NORTHEAST UTILITIES

Docket No. 50-423
B11266

Millstone Nuclear Power Station, Unit No. 3
Submittal of
Revised Response to Effluent Treatment System Open Item

ETSB-1: ESF Atmosphere Cleanup System

PERFORMANCE CURVES

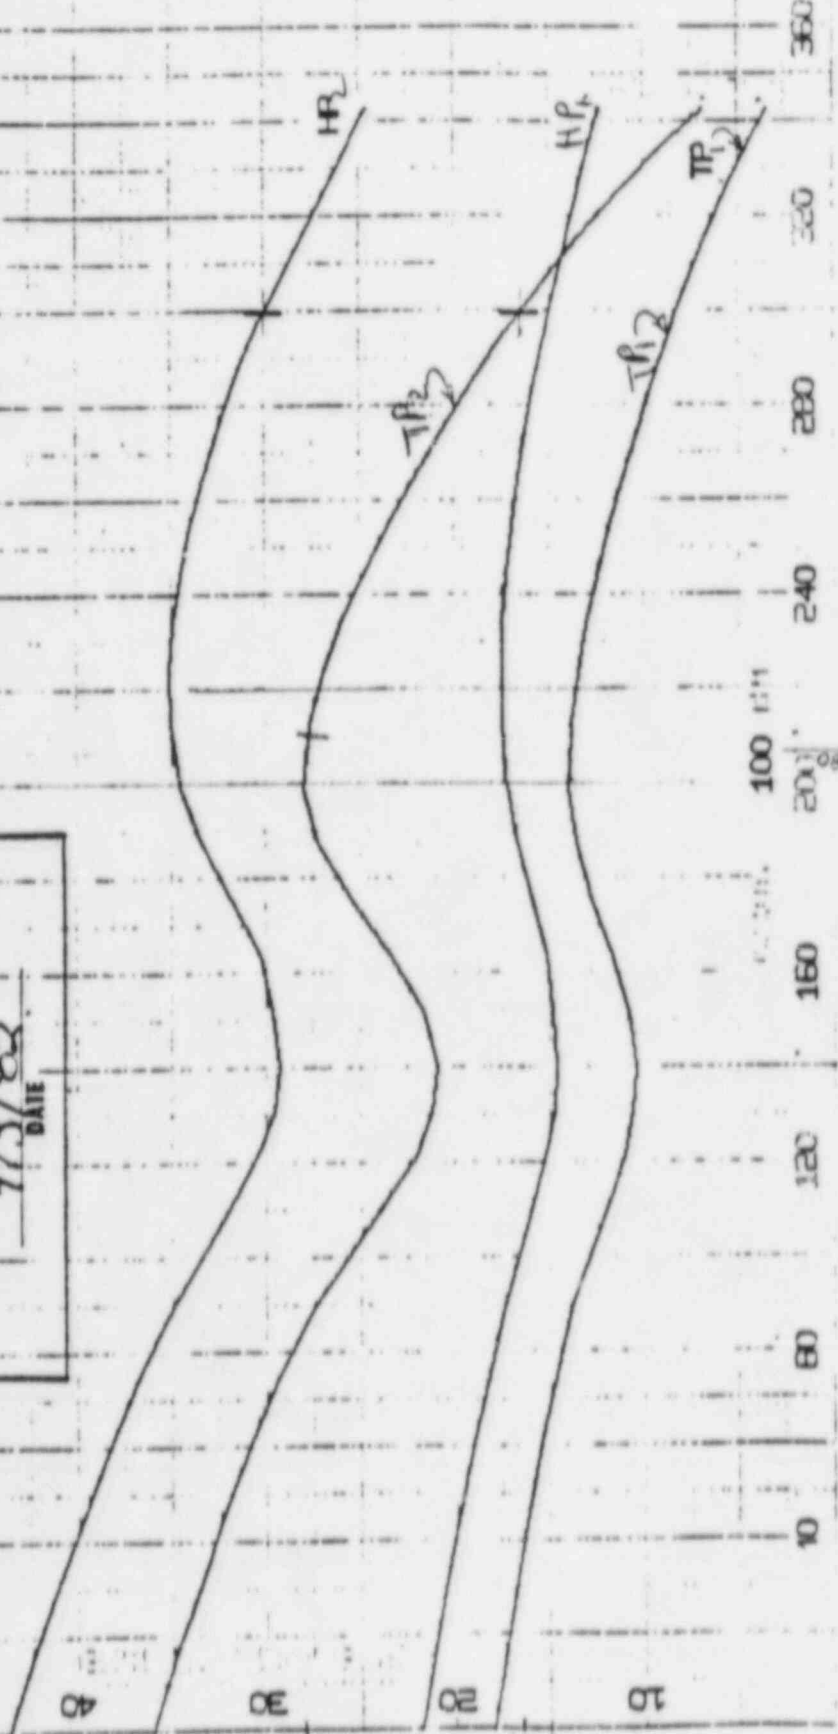
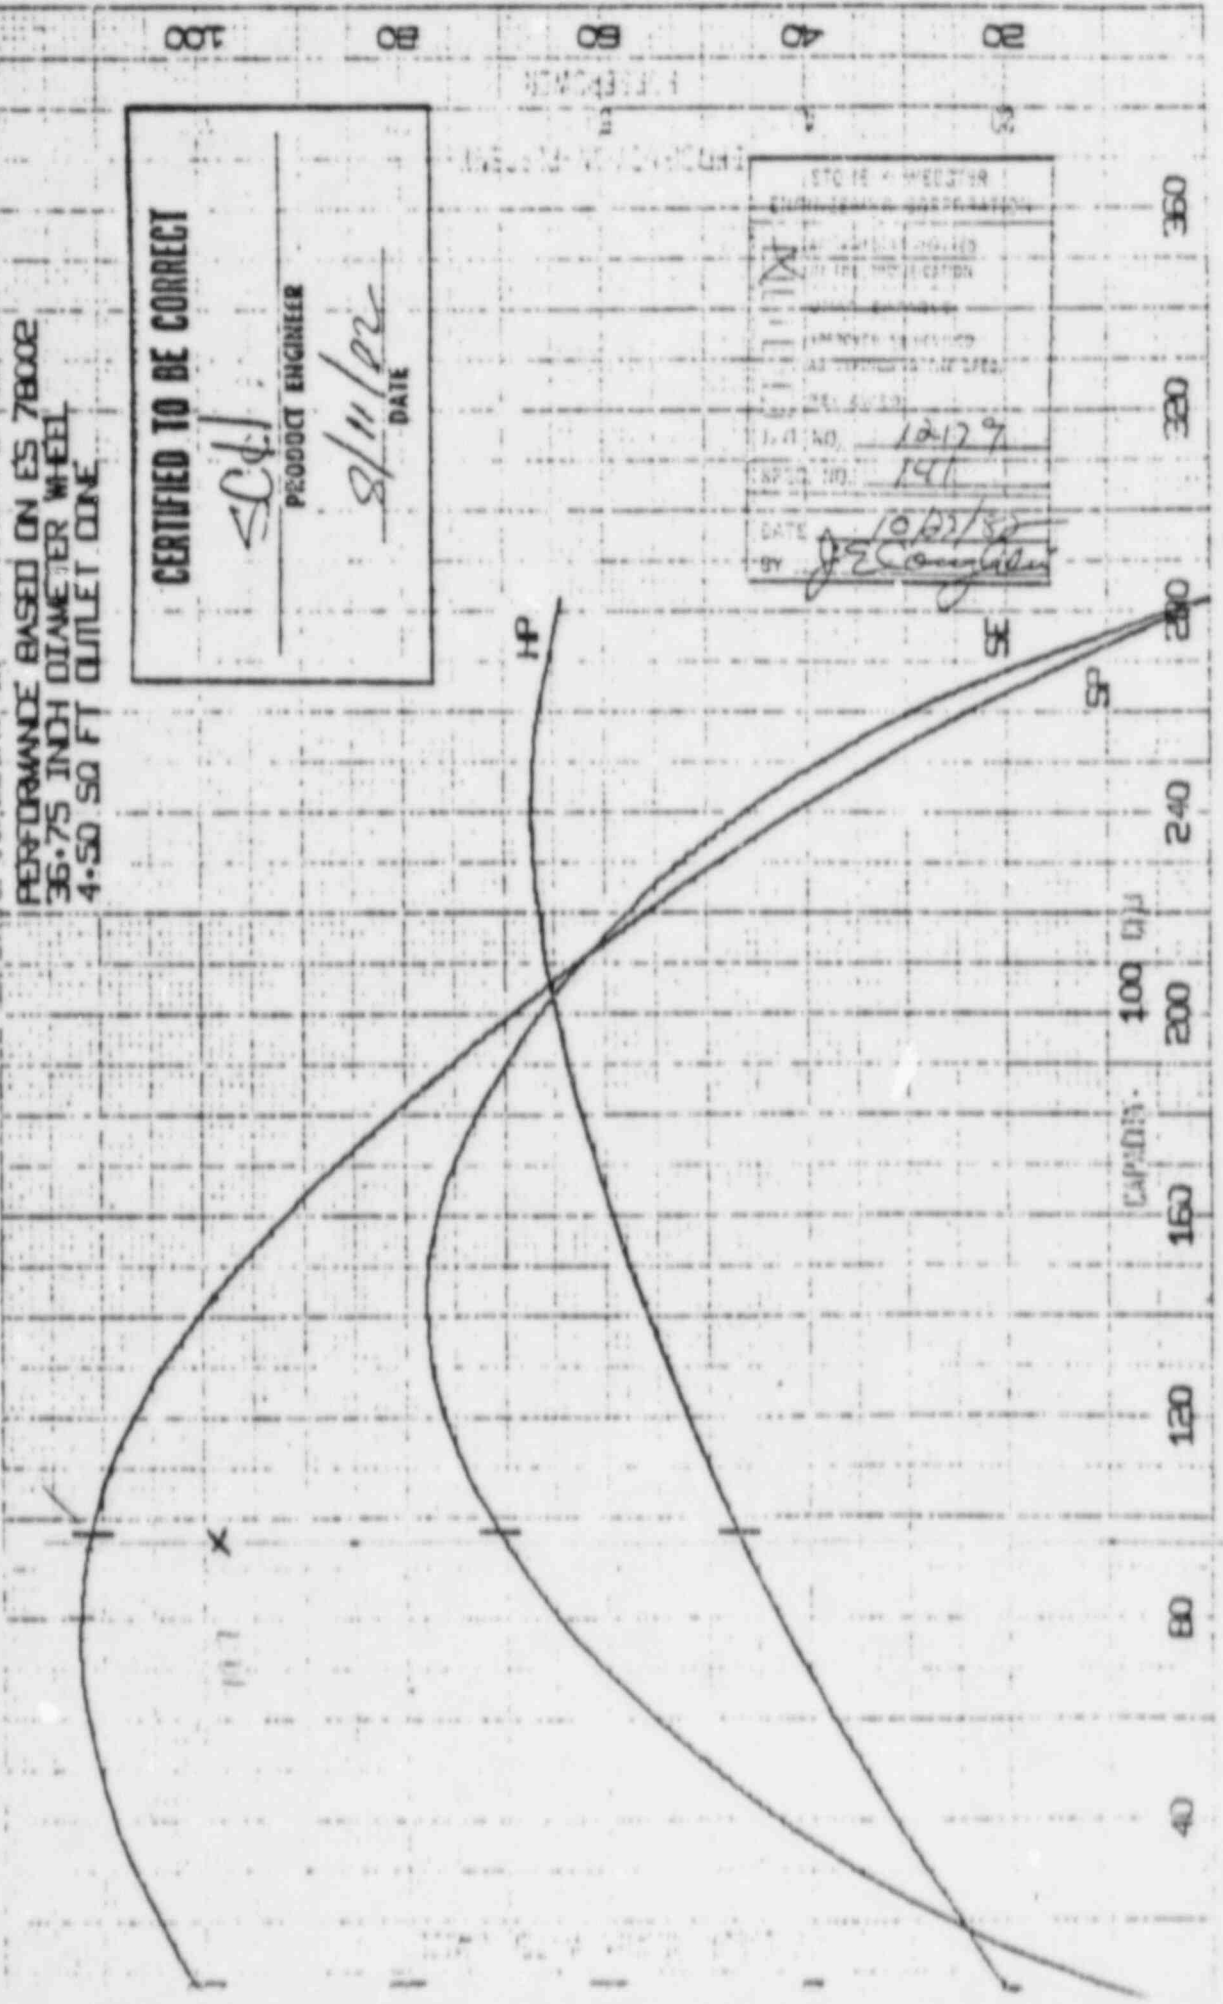
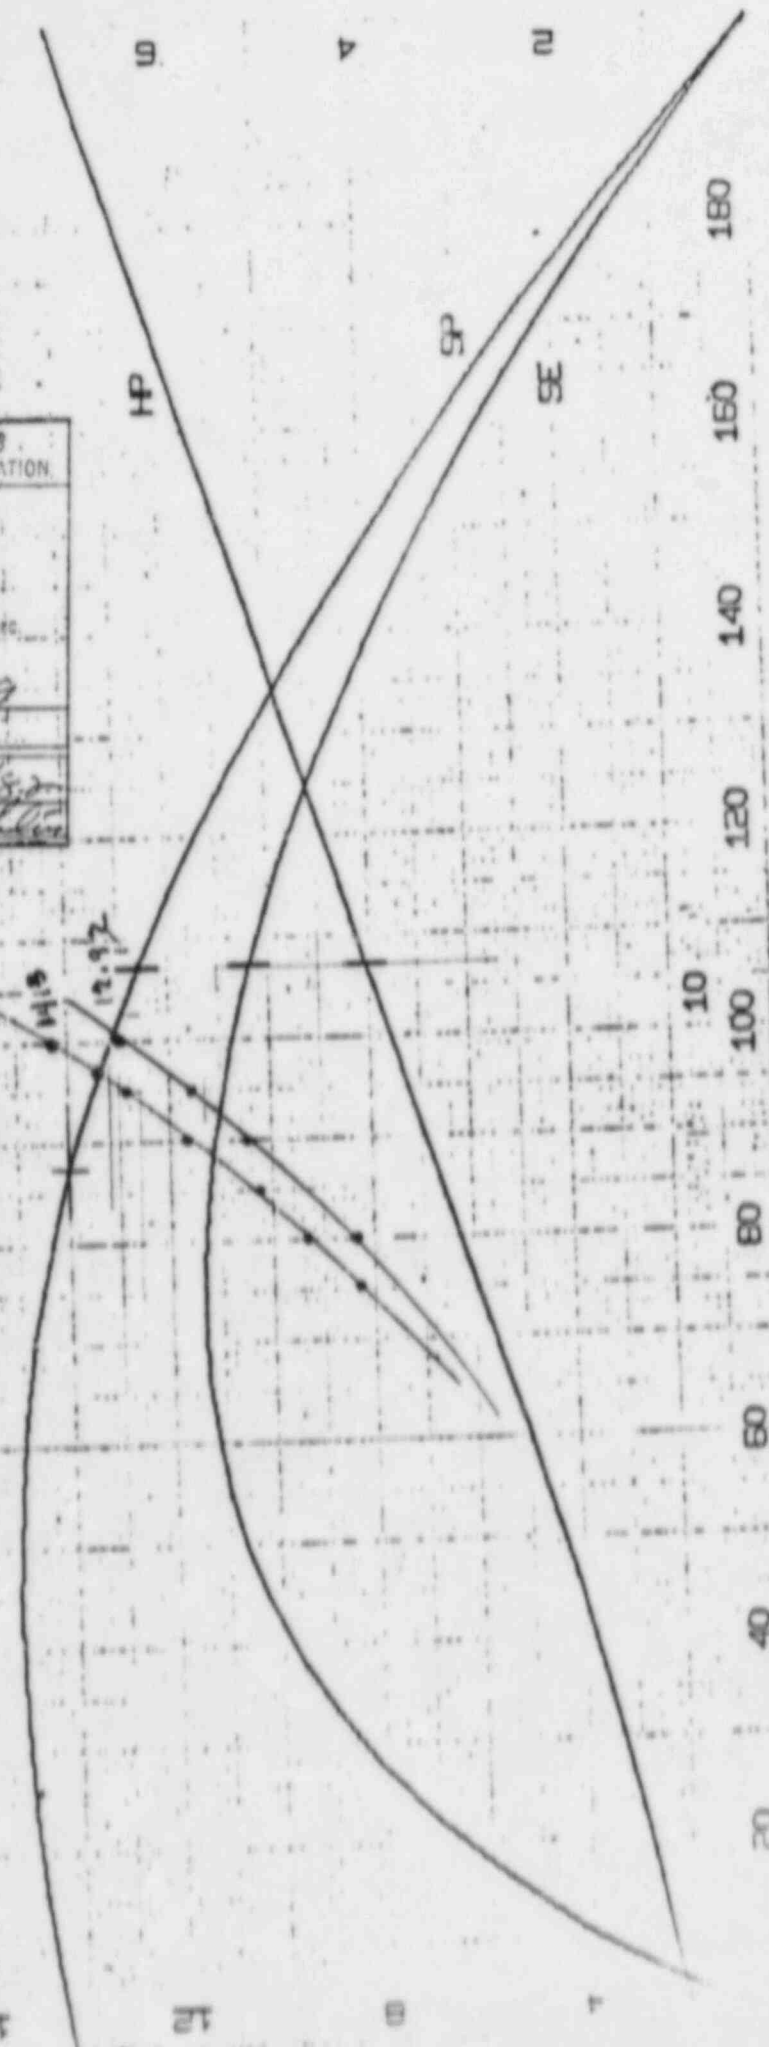
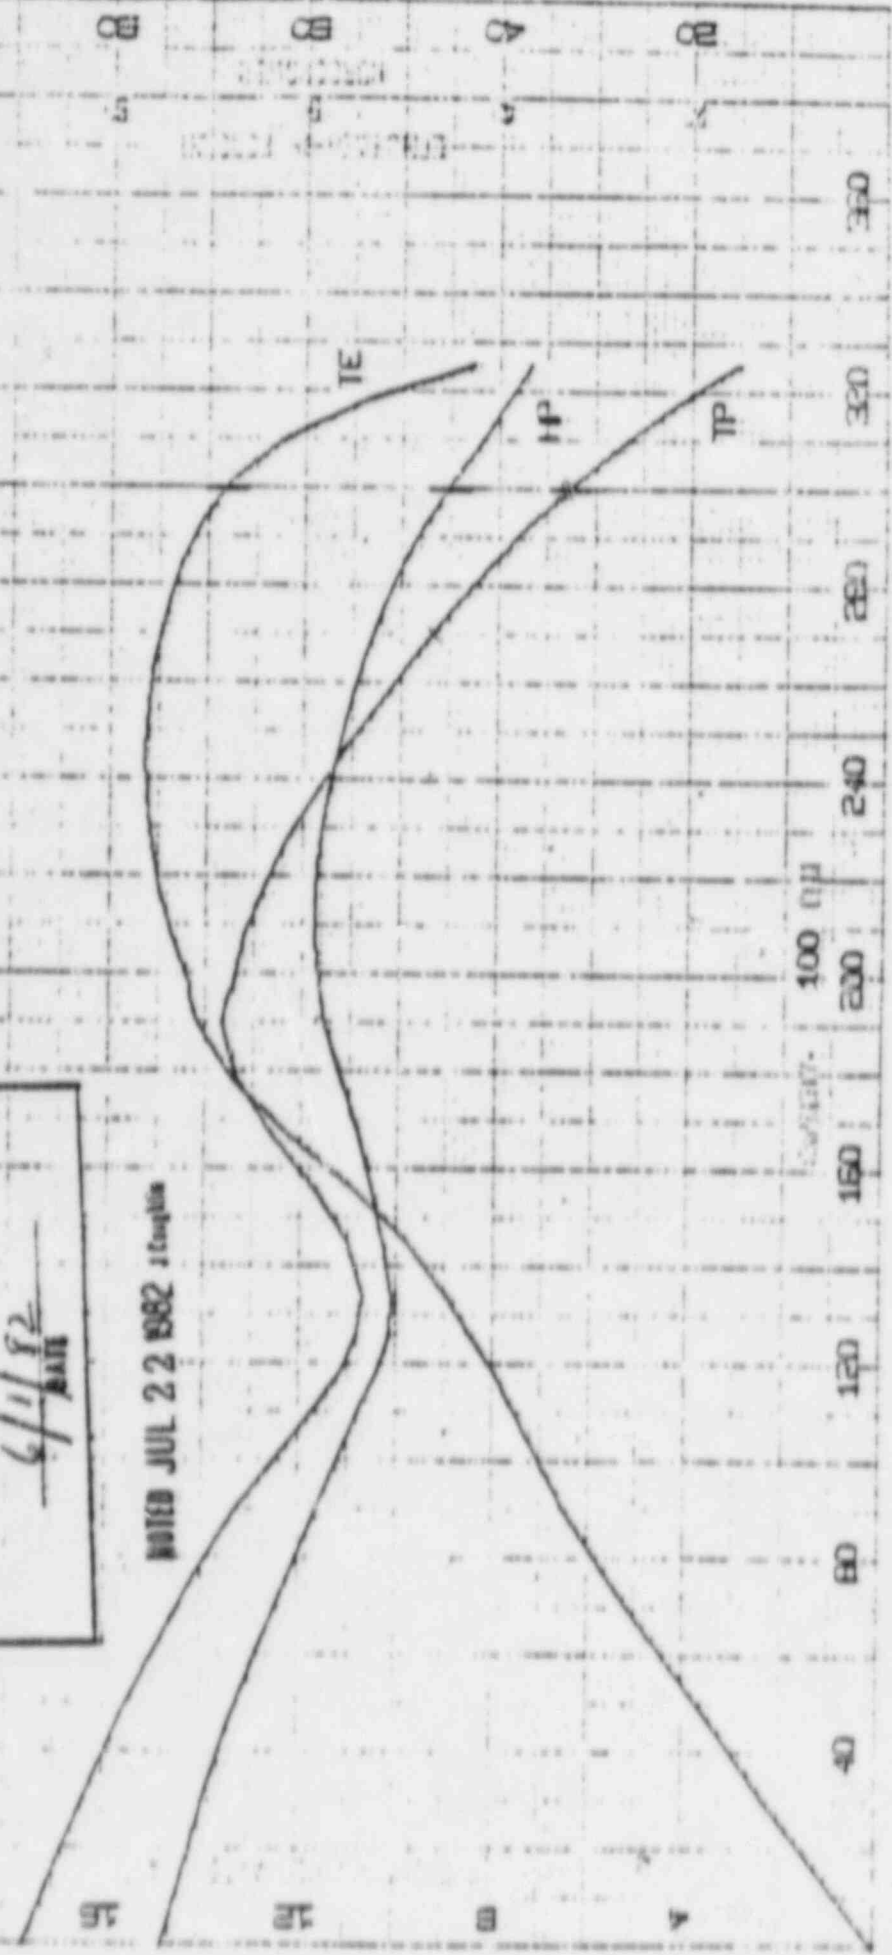
SRP Section 6.5.1, Revisions 1 and 2, and RG 1.52, Revisions 0, 1, and 2, call for each ESF atmosphere cleanup system to be instrumented to signal, alarm, and record pressure drop and flow rate at the control room. Millstone Unit 3 ESF atmosphere cleanup systems are provided with only local pressure differential indicators across each filter with a common alarm in the control room for high pressure differential across the filter bank. The pressure differentials across each filter are transmitted to the plant computer in the main control room. The applicant stated in the FSAR that periodic surveillance tests will be performed to ensure design flow rates through each ESF atmosphere cleanup system. The staff will complete its evaluation after further discussion with the applicant regarding indicators and recorders in the main control room. This issue will be addressed in the final SER. This is an open item.

The ESF systems fans are fixed speed fans, and the system flow rates vs. pressure drops will be verified during plant operation utilizing the attached fan curves.

For the ESF atmosphere cleanup system, high differential pressure across a filter section is alarmed in the control room and monitored by the plant computer to identify the section having the high differential pressure. In the event of a high differential pressure alarm, operator action can be taken to start the standby filter train. In addition, the standby system will start automatically if air flow through the filter is low.
